1957 - 1958 Corvette: Service News: Corvette 4-Speed Transmission - Harsh Shift Into Third Speed

Source: Chevrolet Service News

Date: December, 1957

Subject: Corvette 4-Speed Transmission - Harsh Shift Into Third Speed

Fig. 3—Checking Third Speed Gear

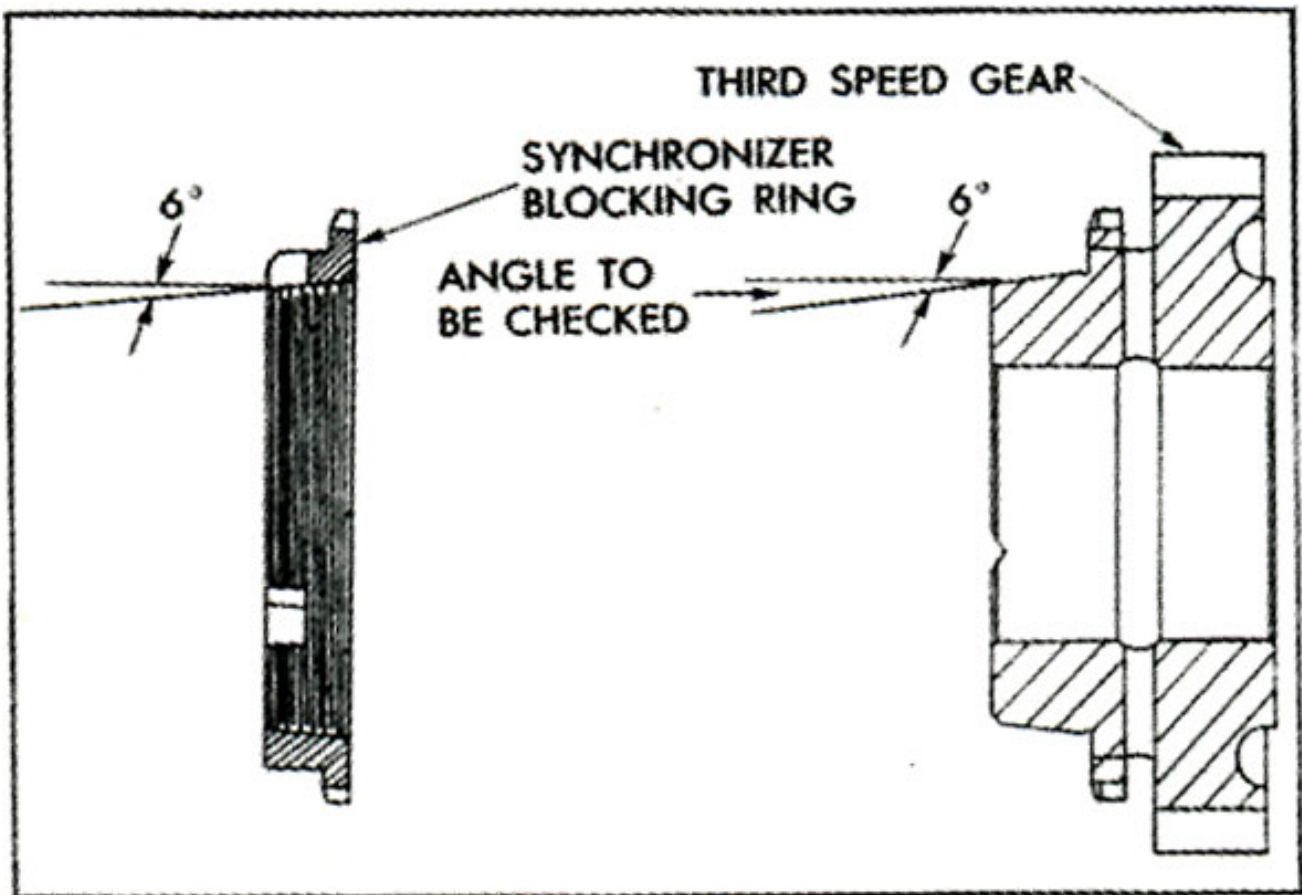
Some 1957 and 1958 Corvette four-speed transmissions have been built incorporating a third speed gear with 7° cone angle rather than the specified 6° , as illustrated in Figure 3. This may cause a harsh shift into third speed due to the resultant improper engagement of the synchronizer blocking ring and third speed gear cone.

The suggested correction, if the harsh shift is encountered, is to replace the third speed gear assembly No. 3743452 and the synchronizer blocking ring No. 3709348.

1. Coat I.D. of blocking ring lightly with a dye such as Prussian Blue.
2. Carefully install the blocking ring on the third gear cone to obtain an engagement impression.
3. If the Prussian Blue impression on the cone is all at the rear (or predominantly at the rear) the cone angle can be assumed to be 7° and should not be used. If the Prussian Blue is more or less evenly distributed on the cone surface, the angle is correct.
